# COMMUNITY BOARD FEEDBACK PACKAGE

**Business Name:** Galaxy Diner

**Cafe Address:** 665 9 AVENUE, NEW YORK, NY, 10036

**Application Number:** 20240801010074

PLAN VIEW  
 Scale: 1/4" = 1'-0"

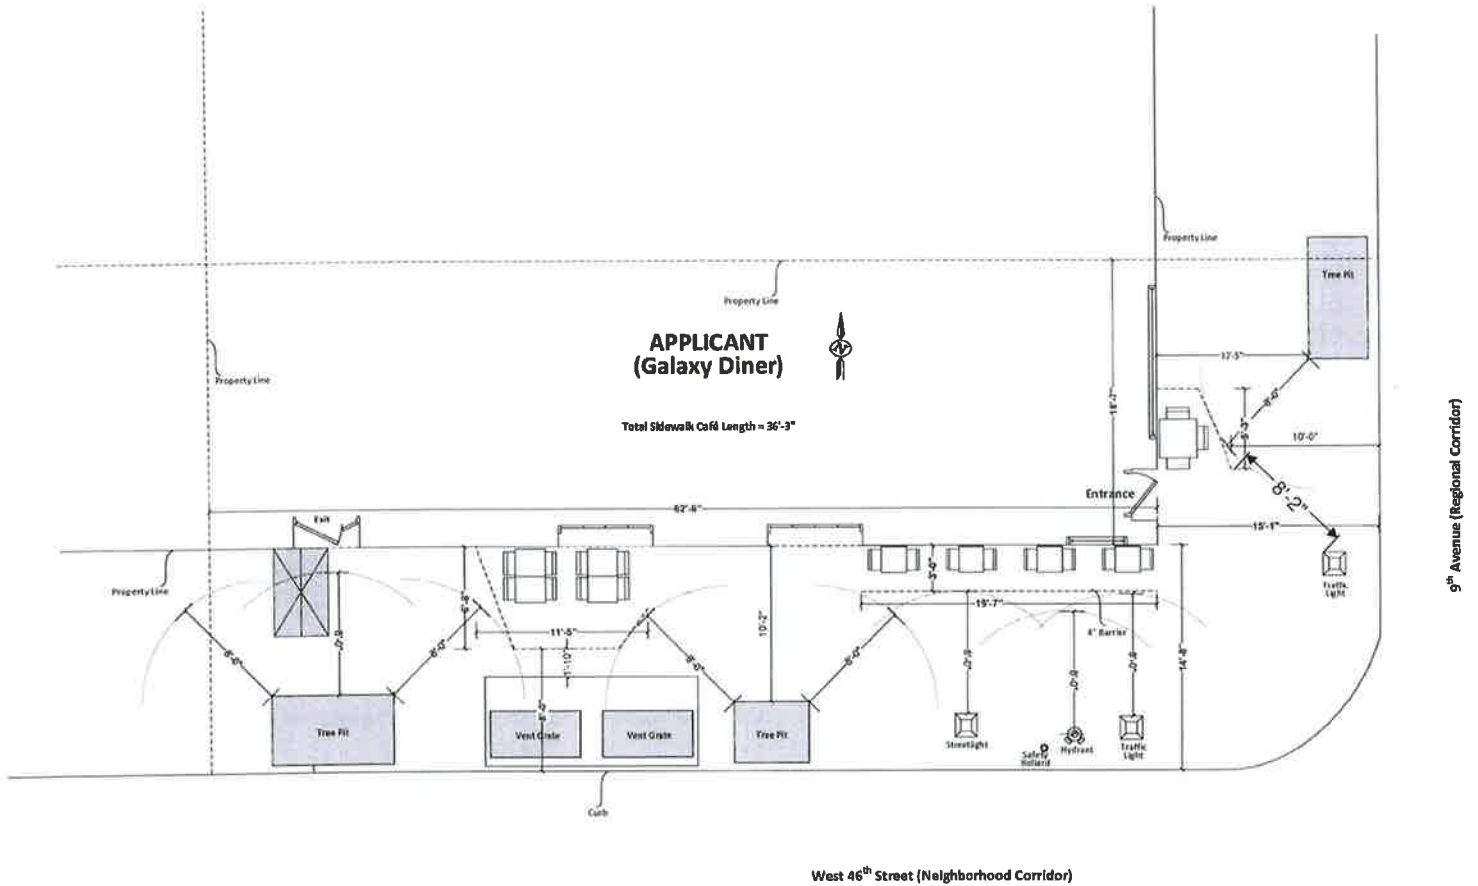
The proposed Site Plan does not provide for the required 10 foot pedestrian clear path along the 9th Avenue side of the sidewalk cafe. To provide for the required clear path, the applicant has agreed to reduce the size of the single table on the 9th Avenue side of the cafe to the same size table used on the West 46th Street side of the cafe -- one table with two chairs.

To provide for the required 10 foot pedestrian clear path, MCB4 requests that the size of the single table on the 9th Avenue side of the cafe be reduced to the same size table used on the West 46th Street side of the cafe -- one table with two chairs. Applicant has agreed to this modification.
